ADDENDUM NO. 2

**PROJECT: PASCAGOULA-GAUTIER SCHOOL DISTRICT
GAUTIER ELEMENTARY SCHOOL KITCHEN RENOVATION (RE-BID)
(JBHM PROJECT NO. 22050.01)
GAUTIER, MISSISSIPPI**

**ARCHITECT: JBHM ARCHITECTS, P.A
308 EAST PEARL STREET, SUITE 300
JACKSON, MISSISSIPPI 39201**

3 Cafeteria - Interior Wall Section at Storefront
1" = 1'-0"

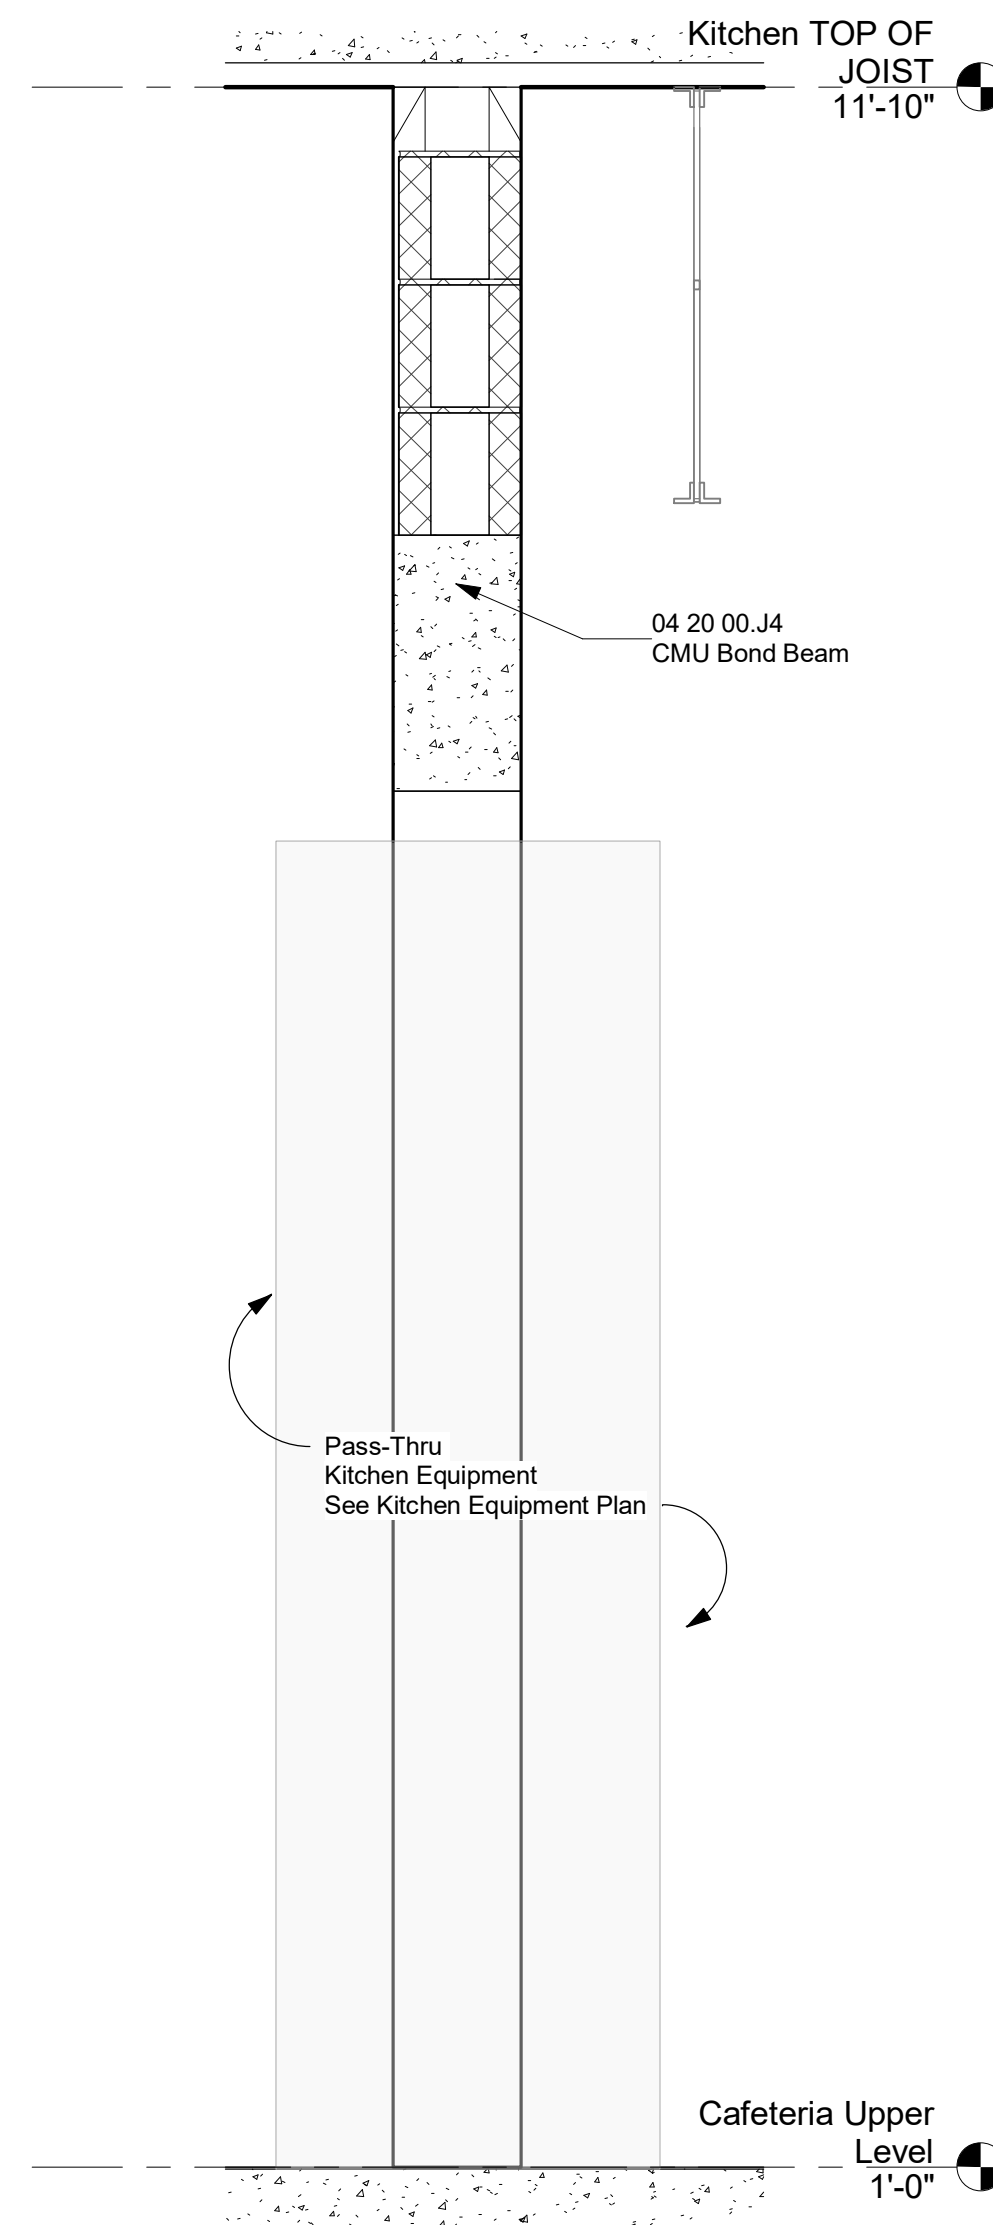
- Item No. 12: SHEET A201:
- A. Refer to the attached supplemental drawing SD-01 dated 09/06/2023 for misc. details which apply at the Serving Line Storefront, Pass-Thrus, and Can Wash.
- Item No. 13: SHEET A601, DOOR AND FRAME SCHEDULE: Revise misc. items as follows:
- A. Revise Exterior Door No. 03 (Loading Dock) to Galvanized Hollow Metal, Painted Finish. Add a narrow view lite in Door No. 03.
- B. Revise Exterior Door No. 11 (Boiler Room) to Galvanized Hollow Metal, Painted Finish.
